**NOTICE OF DECISION**

**Concept Design Review – New 3- to 6-story, 254,152 square-foot mixed use development  
740-790 E. Green Street  
Case #: DHP2022-00248**

**ATTACHMENT A:  
CONDITIONS OF APPROVAL  
740-790 EAST GREEN STREET  
CONCEPT DESIGN REVIEW**

1 Site  
1" = 30'-0"

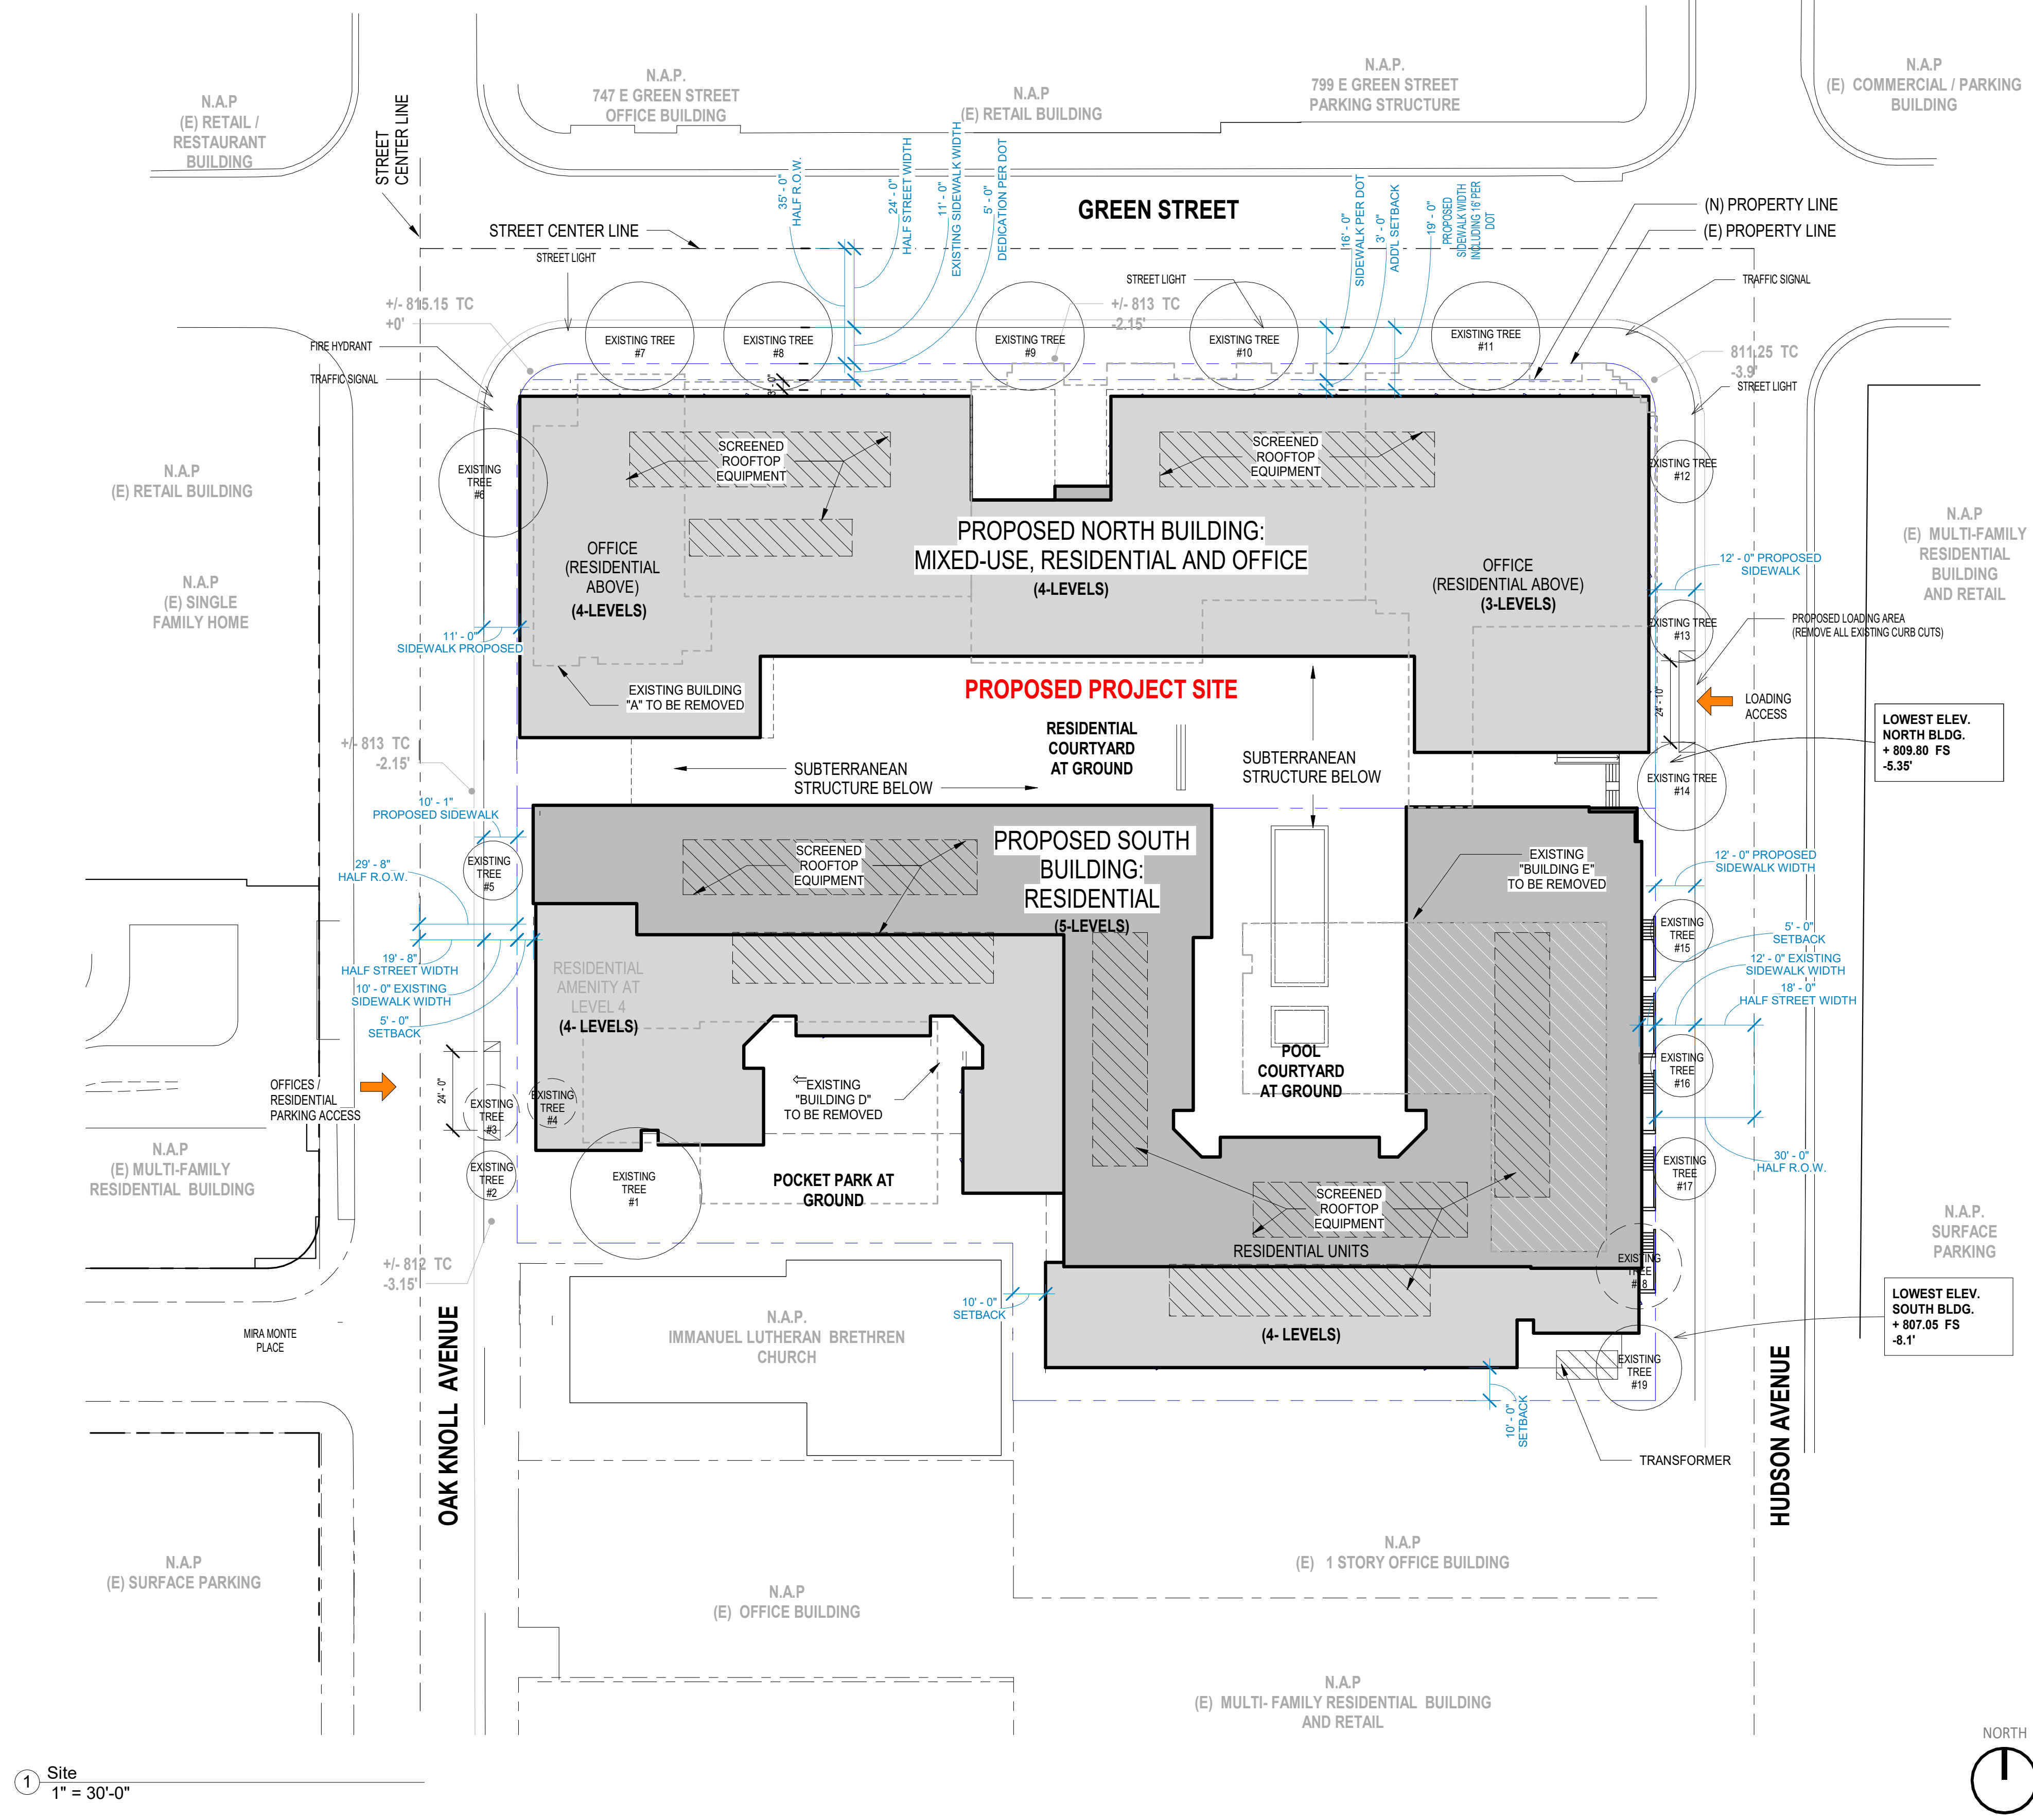
- a. Site plan does not clearly identify the proposed property lines after required dedication along Green Street. Plans show that there is a proposed 19’ sidewalk on Green Street, where 16’ is required by DOT. The additional 3 feet is not a required dedication and is considered a part of the private property. Please clarify the new proposed property line along Green Street. Setbacks are measured from the proposed property lines, after street dedication.
- b. Per Zoning Code Section 17.30.040, Figure 3-7 “Central District Required Setbacks”, the following setbacks are required:

# TOPOGRAPHIC SURVEY

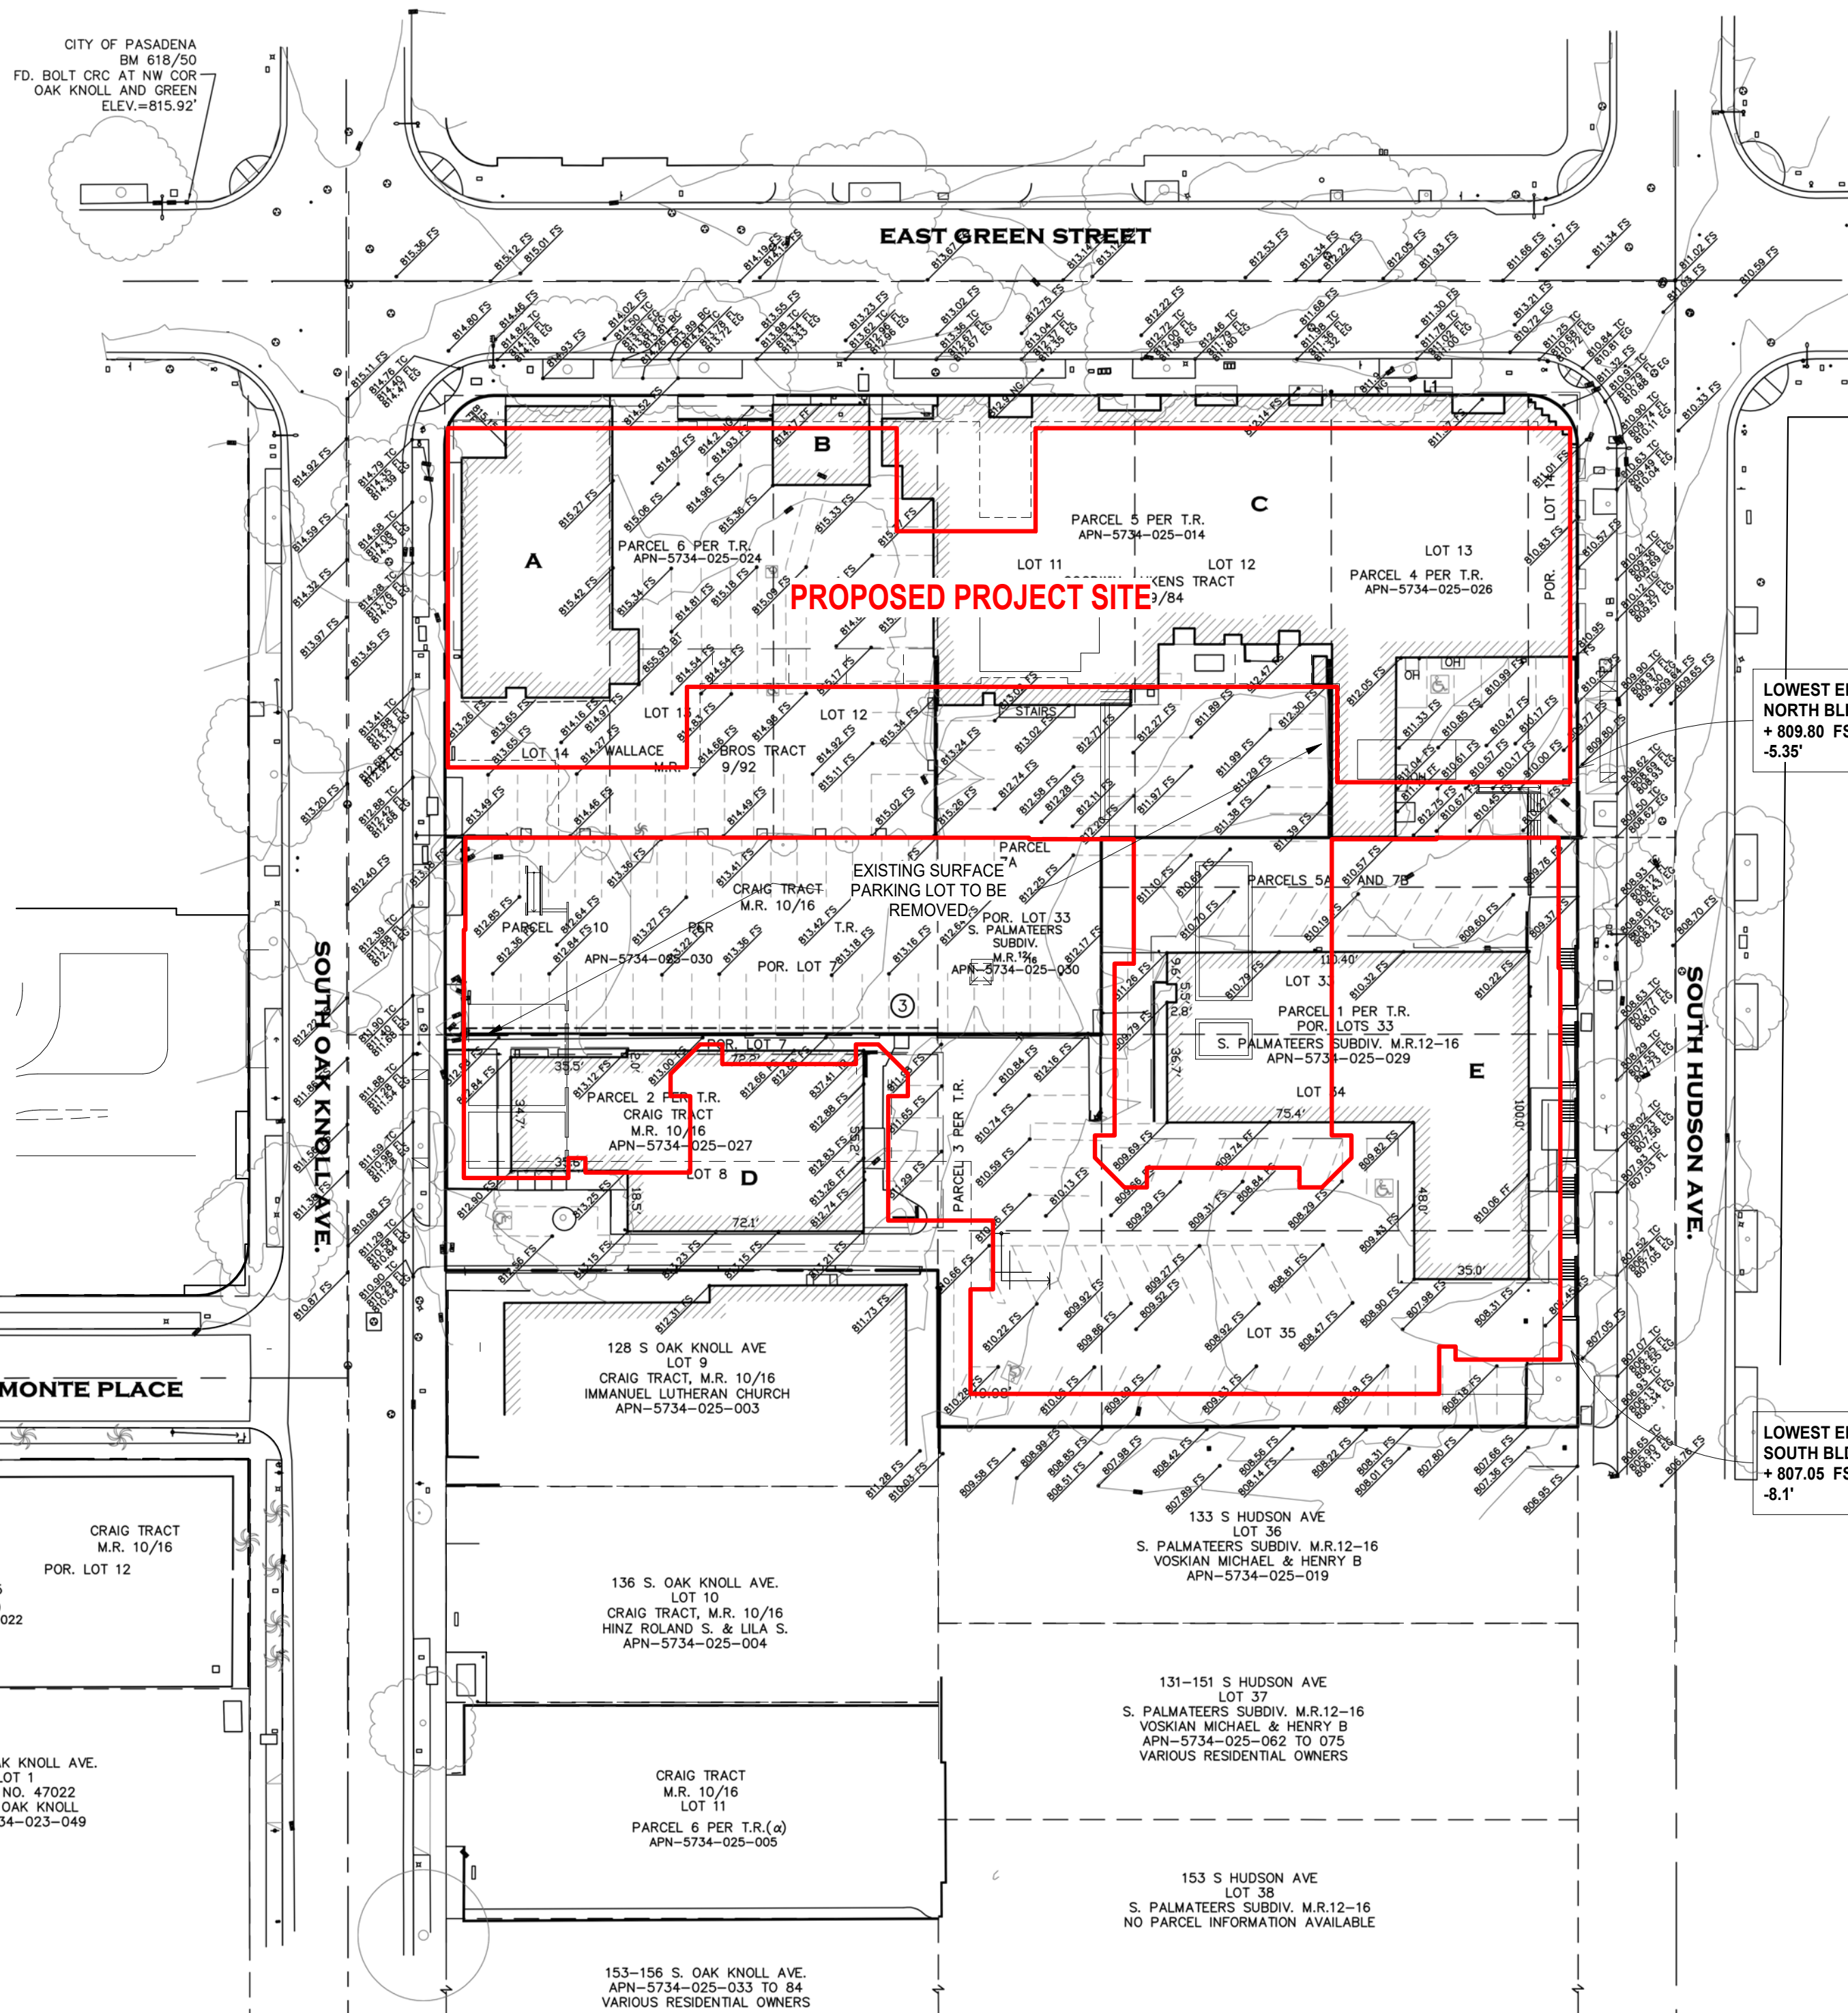
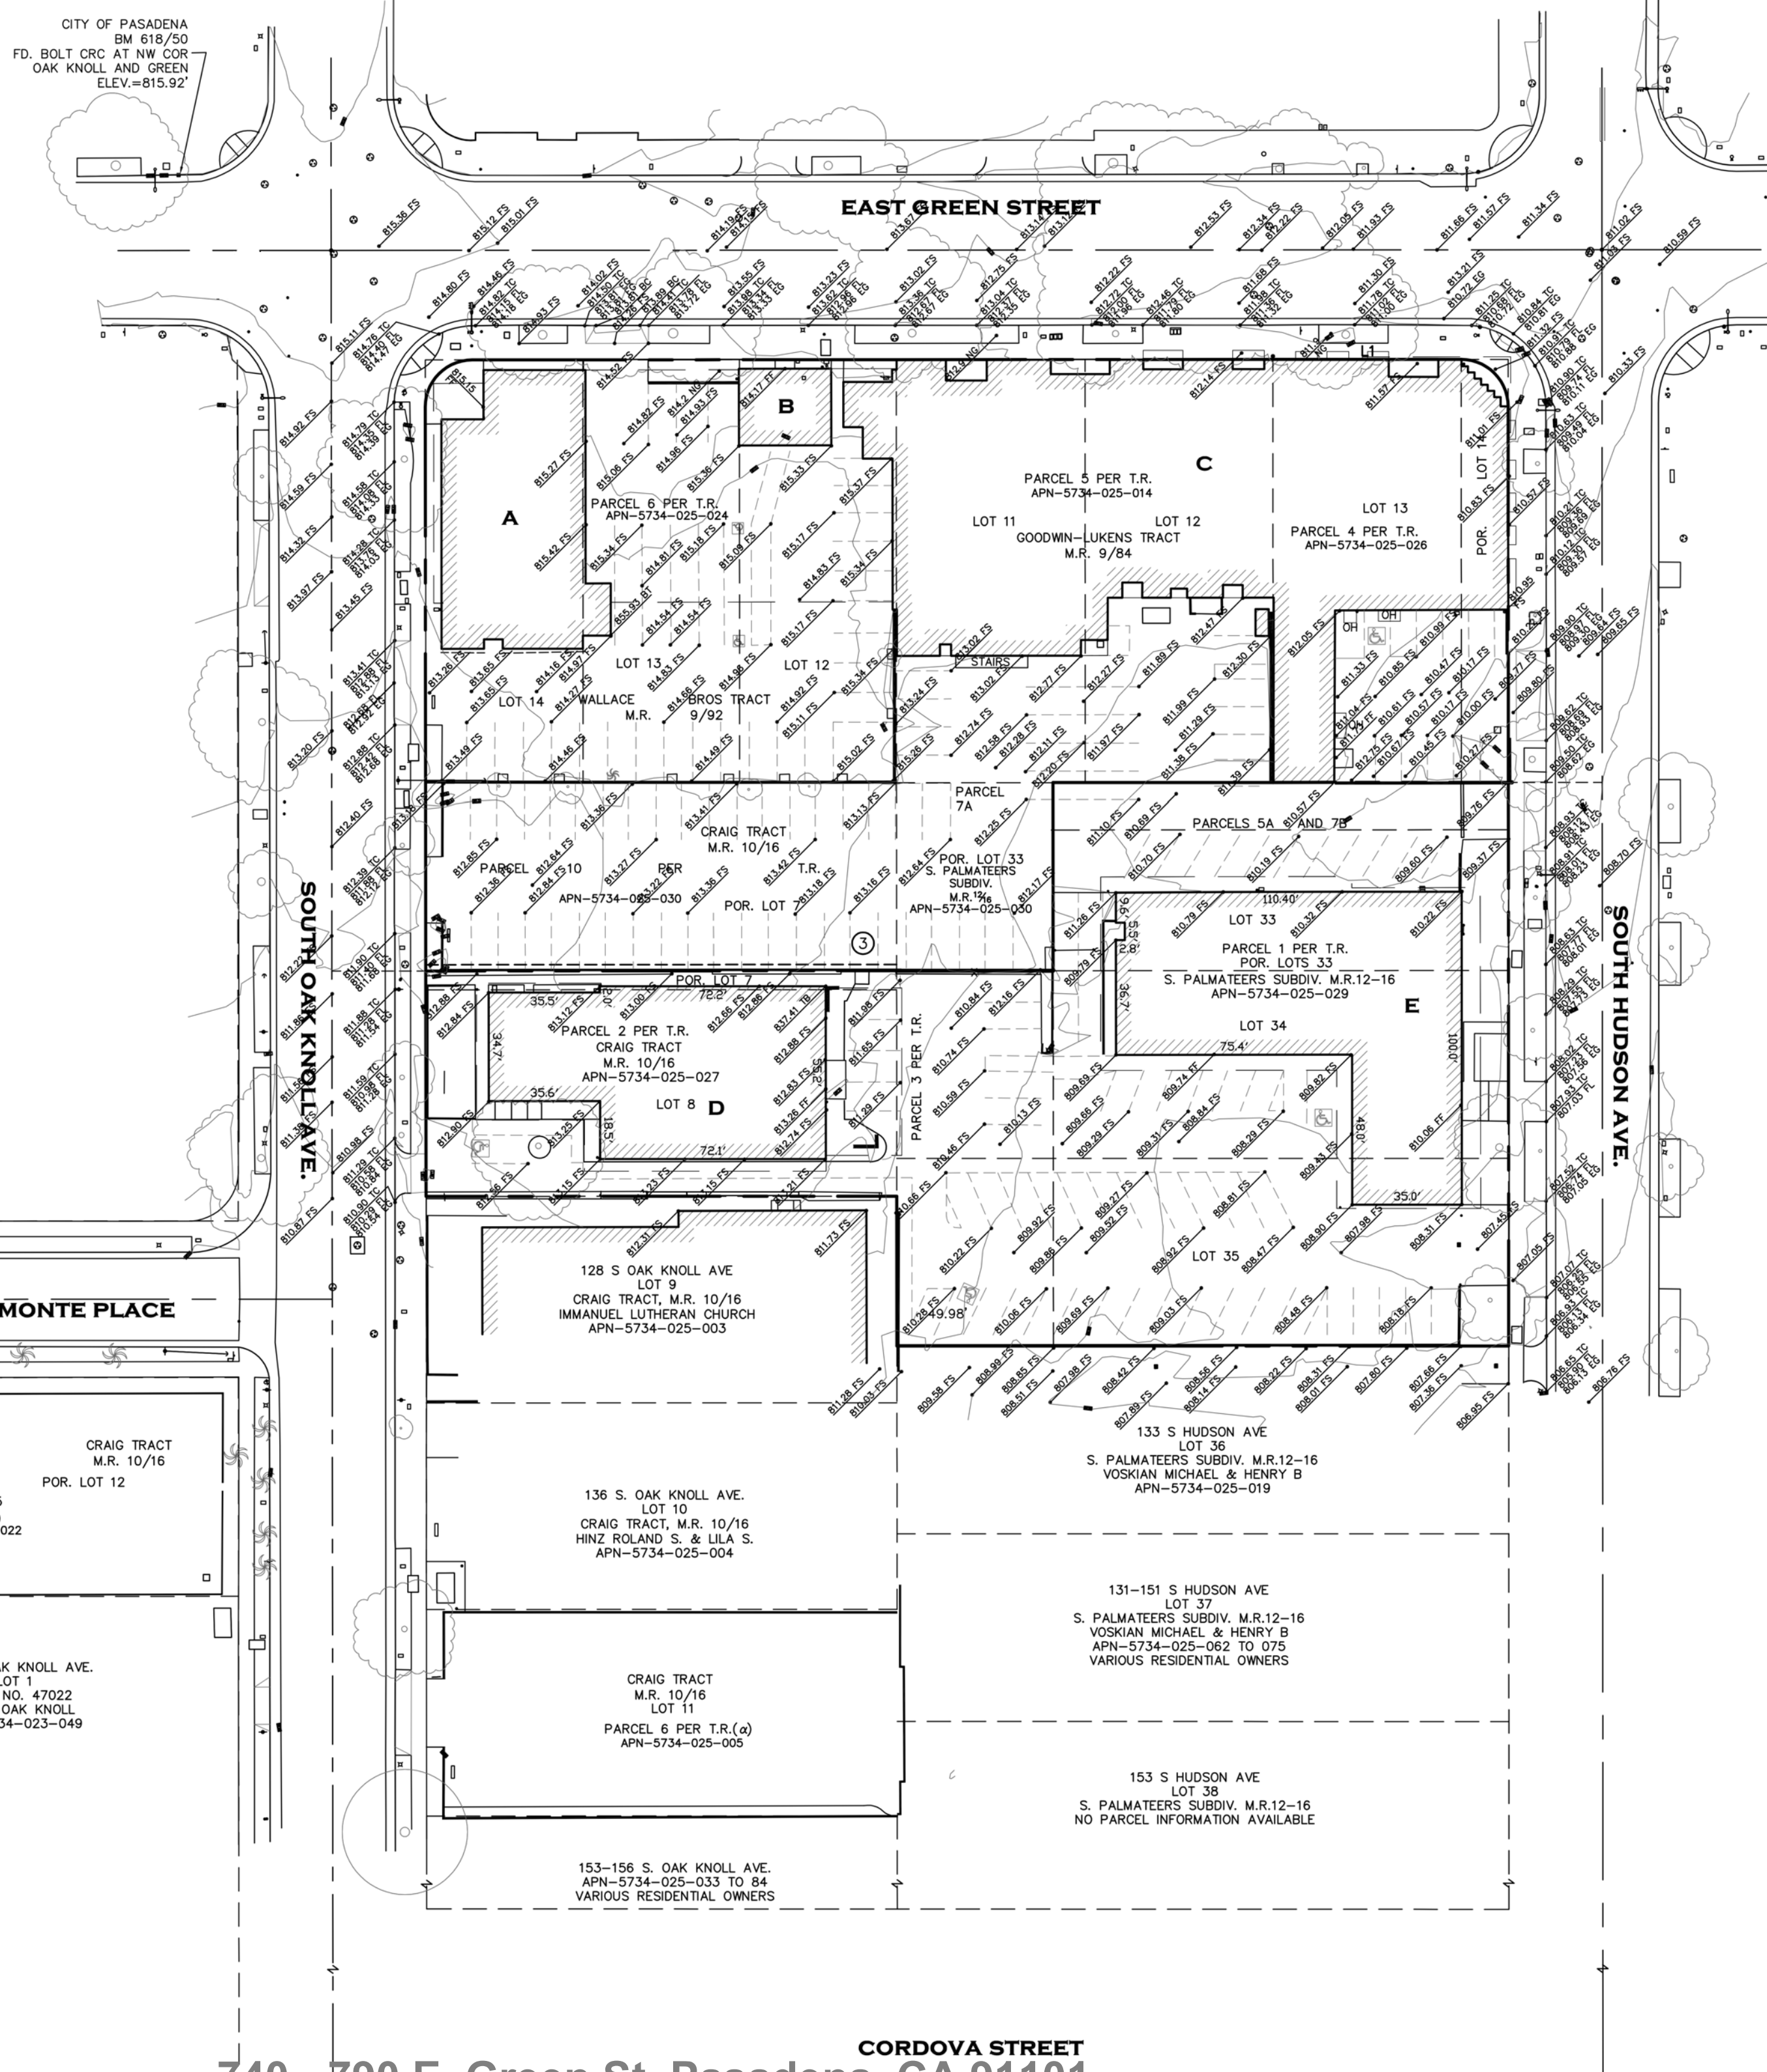
On a separate plan, include an outline of the proposed footprint and identify the lowest existing grade at an exterior wall of the proposed structure.

- i. Identify on the existing topographic survey the low existing grade abutting the footprint of the proposed structure.
